HISTORIC LANDMARK COMMISSION
STAFF REPORT

**TRACY AVIARY BIRD HOLDING BUILDINGS
AND AMPHITHEATER**

PLNHLC2011-00648

June 7, 2012

Attachment E
Proposed Amphitheater Plans

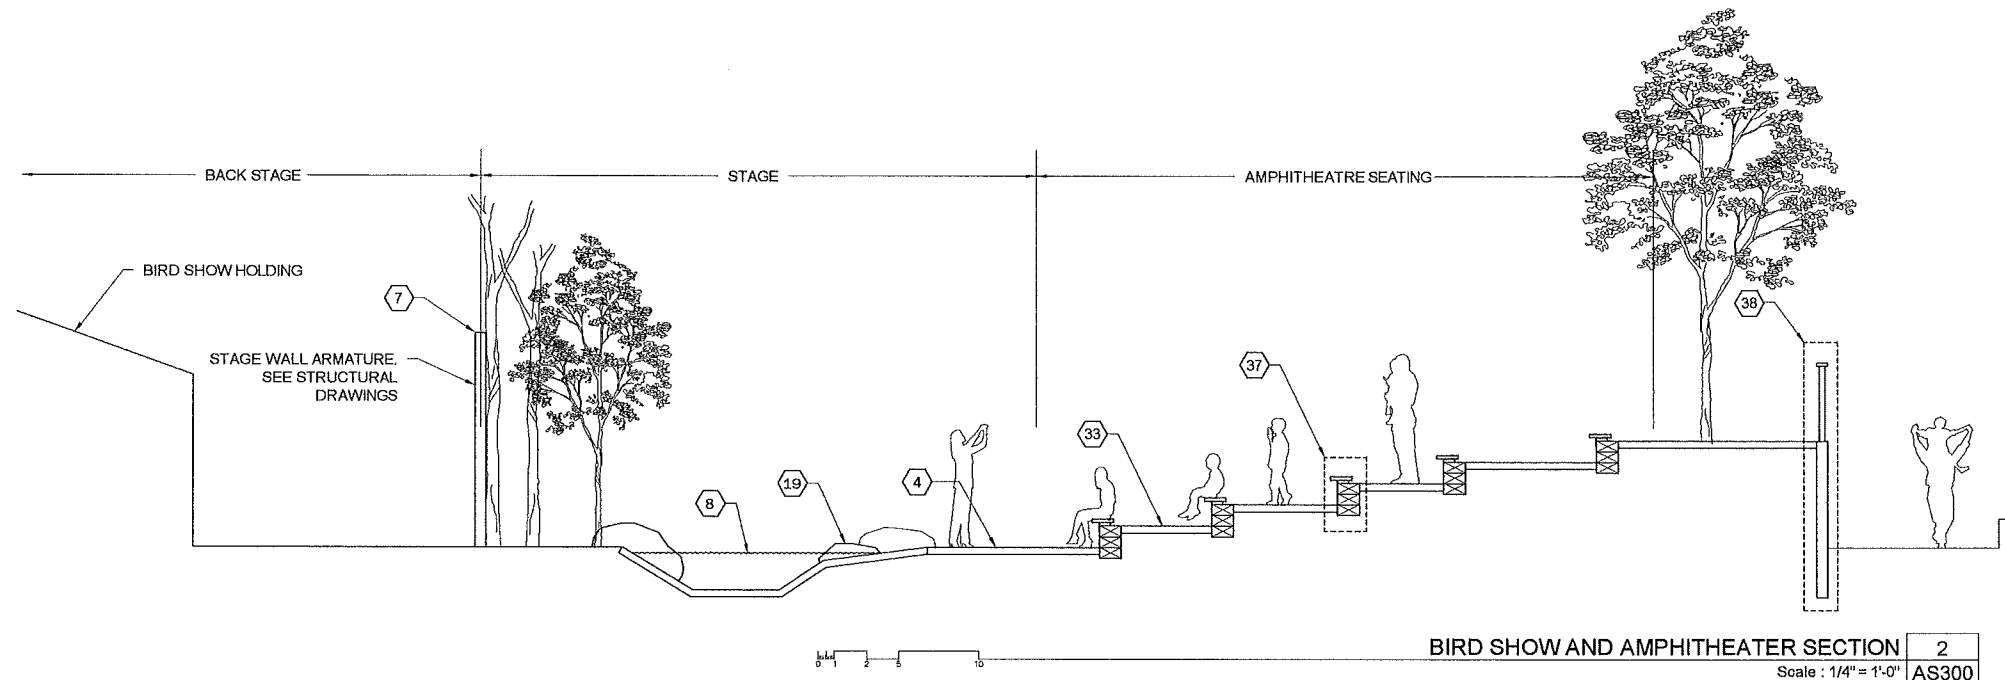
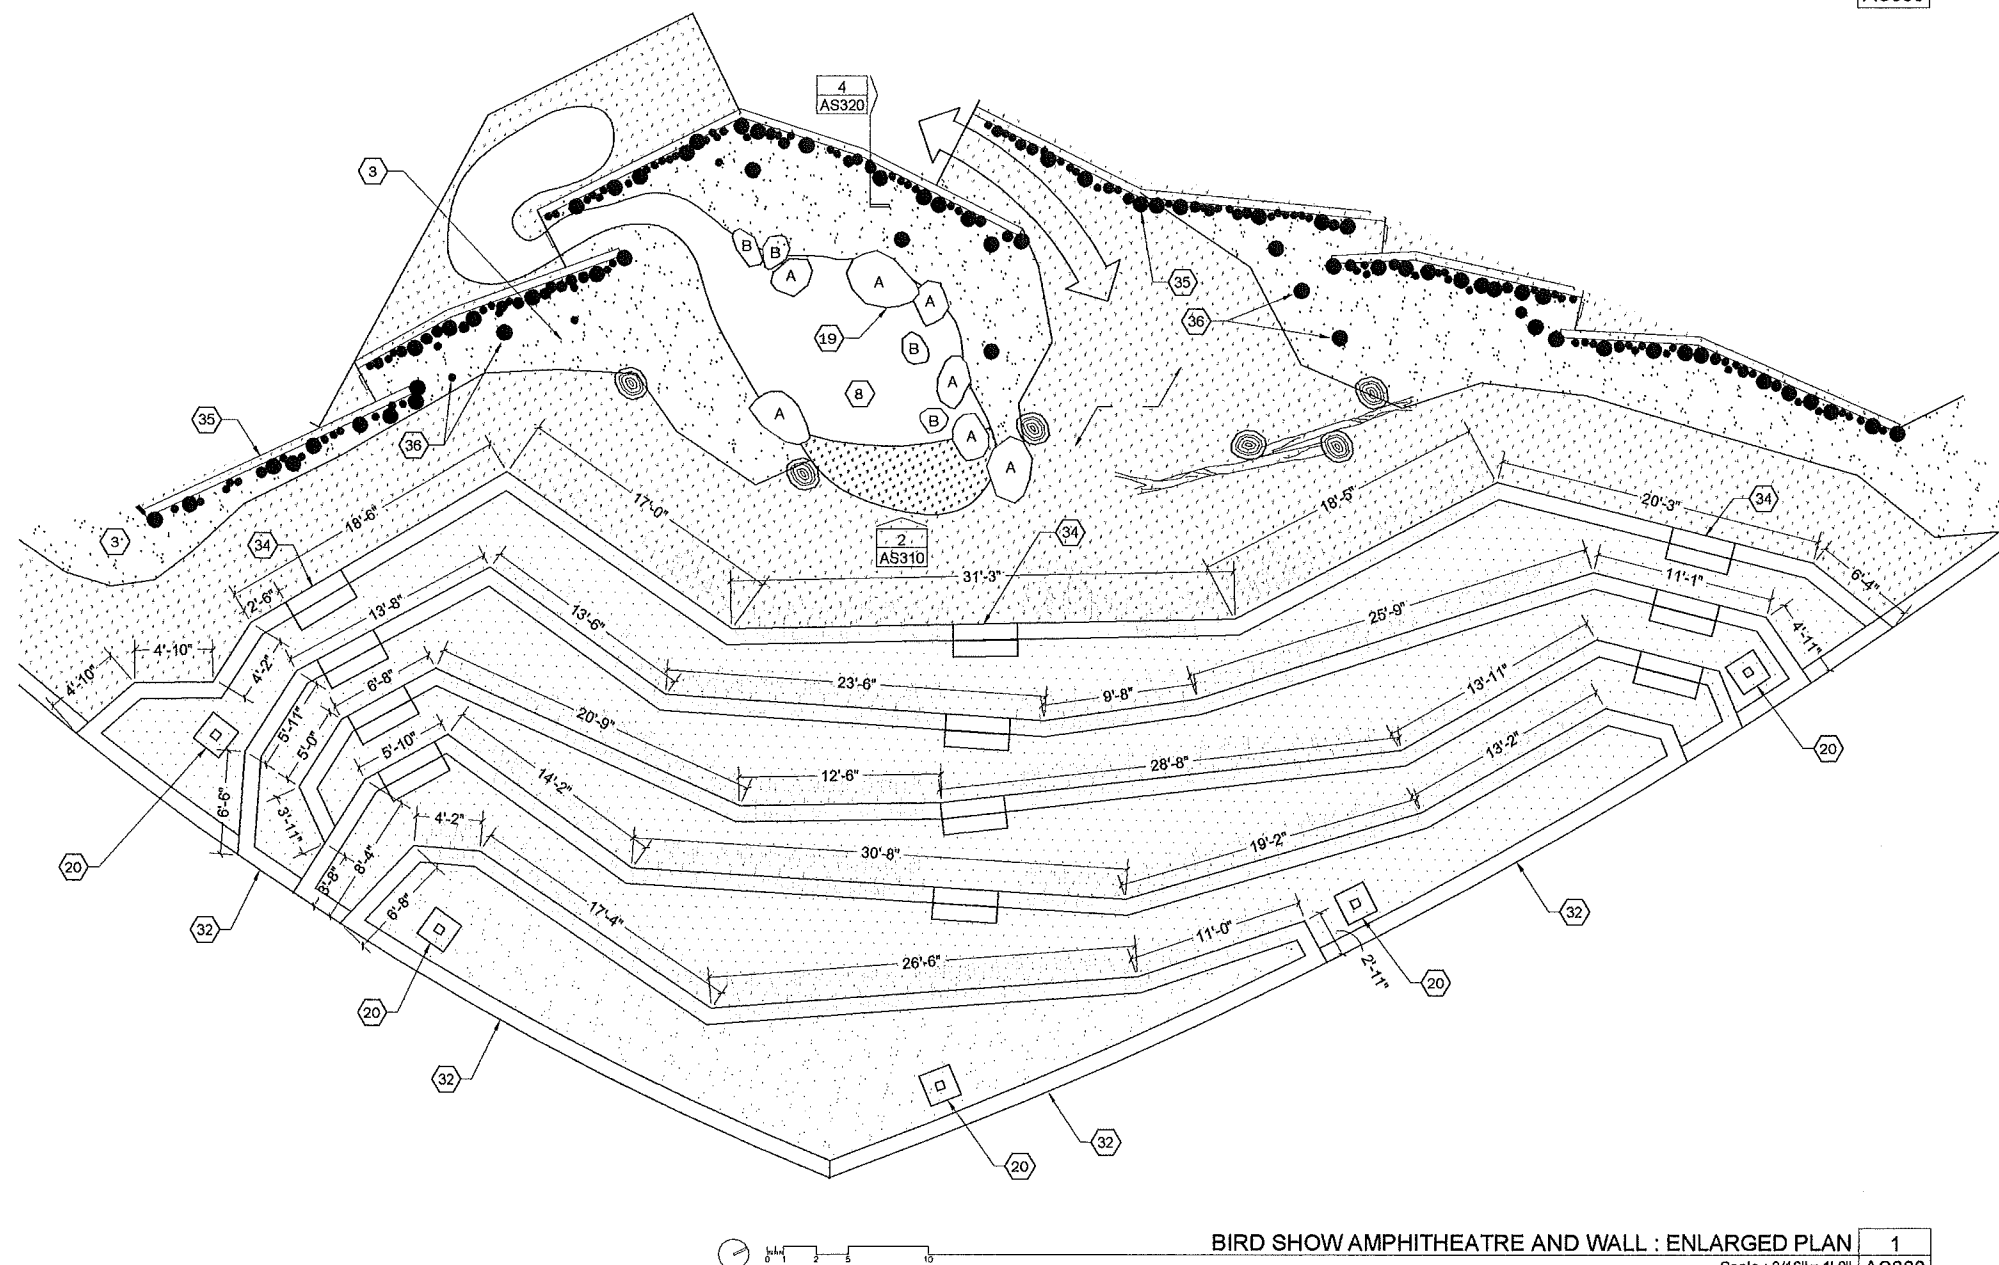
Due to the unique use of the amphitheater, the form, scale and mass of the structure (including the stage wall) is wholly unique. The width and shape of the stage and associated amenities is designed to accommodate the needs of the show, and provide patrons with sight angles to best view the program.

Finding: Staff finds that the 3 proposed buildings are similar to those found throughout the aviary, they are utilitarian buildings designed to cater to the birds, their care takers, and aviary visitors. The unique design of the amphitheater is appropriate due to the needs of the use (bird show support and viewer sight lines). The 13 foot height and the relatively narrow width and length of the building makes it compatible in height, width, proportion, scales, massing and roof shape with other buildings in the Aviary.
